8.4 A LEIGHTON - RECONFIGURING A LOT - BOUNDARY REALIGNMENT - LOT 77 ON HG470 & LOT 148 ON HG569 - 229 RANDAZZO ROAD, MAREEBA - RAL/23/0005

Date Prepared: 9 August 2023

Author: Coordinator Planning Services

Anne Leighton
Proposed Boundary Realignment
Lot 148 on HG569 & Lot 77 on HG470, Randazzo Road, Paddys Green

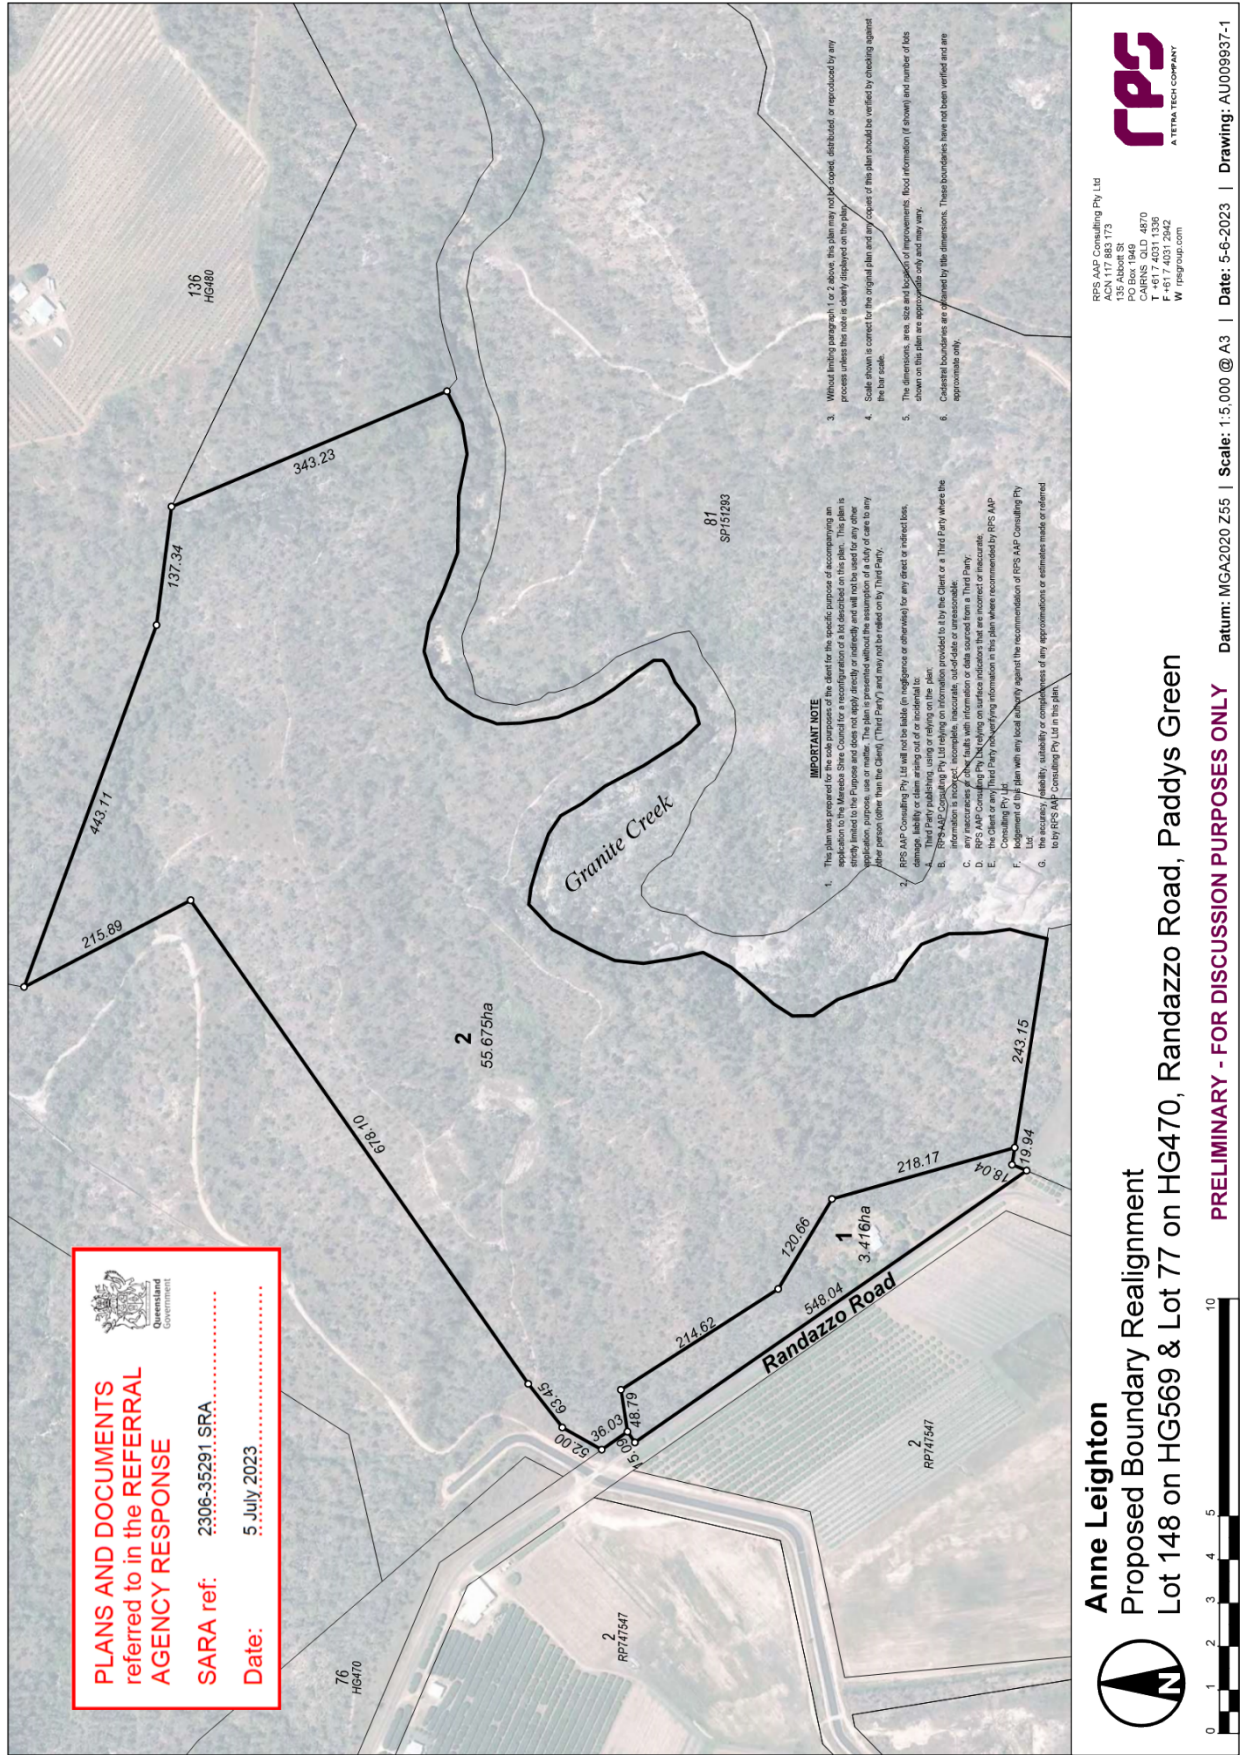
The boundary realignment is limited to a land swap to provide legal access to proposed Lot 2. Existing Lot 148 (proposed Lot 2) is currently landlocked.

No new allotment less than 60 hectares in area will be created.

The boundary realignment is limited to a land swap to provide legal access to proposed Lot 2.

The boundary realignment remedies an historic error which allowed Lot 148 to be sold by the State without legal frontage/access.

The frontages proposed for each lot are appropriate.

- 4.1 An access crossover must be constructed (from the edge of the road pavement of Randazzo Road to the property boundary of proposed Lot 2) in accordance with the FNQROC Development Manual, to the satisfaction of Council's delegated officer.
